Title Proposed Garage Extension with Rooms for Relative Above & Indoor Pool, to Ridgeway House, Childery, Oxon, for Mr & Mrs S. Lewis-Przyde OX12 9UL
 Drawing No. **RHC/01**
 Sheet 1 of 3 Sheet

Re: CHD/16632/2 - Ridgeway House, West Street, Childrey OX12 9UL

Thank you for sending the plans for the proposed extension to the above property for the Childrey Parish Council to comment upon. The views given below are the collective opinions of the Parish Council and are not in any particular order.

FRONT ELEVATION

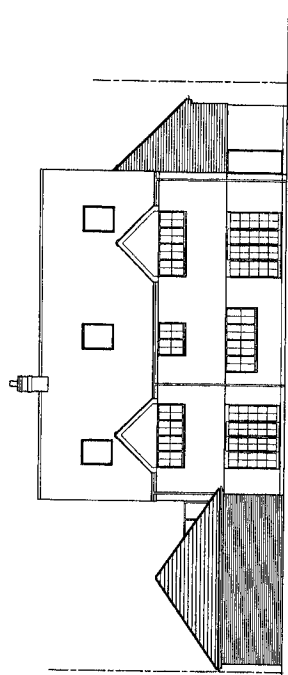
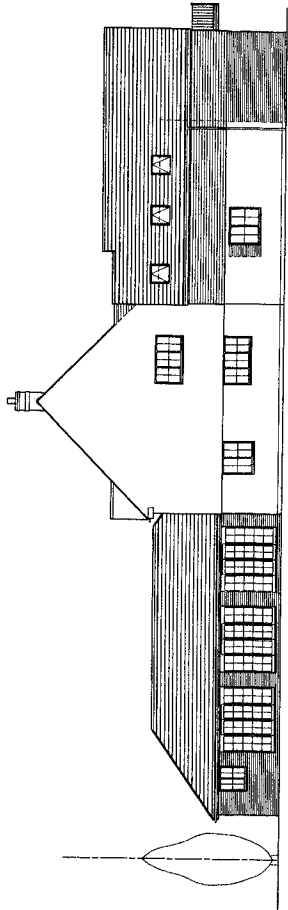
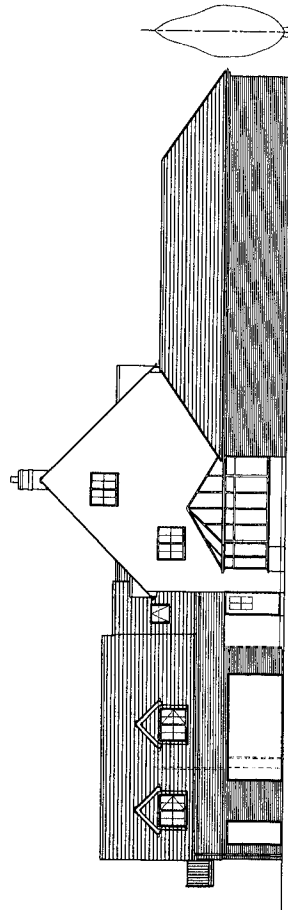
The plans submitted with the application are incomplete and inaccurate. Firstly, there is no first floor plan for the garage flat and secondly, the elevations state a scale of 1:100 whilst the ground floor plan states a scale of 1:50. However, they are the same scale. The house in question originally had a floor area of approximately 231 sq.mtrs. It has already been subject to further development, namely a conservatory and a full size loft conversion, adding about 116 sq.mtrs. The new proposal seeks to add a further 163 sq.mtrs of floor space. This represents a total increase of floor space of 120%, a disproportionately large percentage. GS3 of the local plan, appropriate elsewhere, states the maximum allowable increase of 30% for a house of this size. The % increase over the existing floor space is 45%.
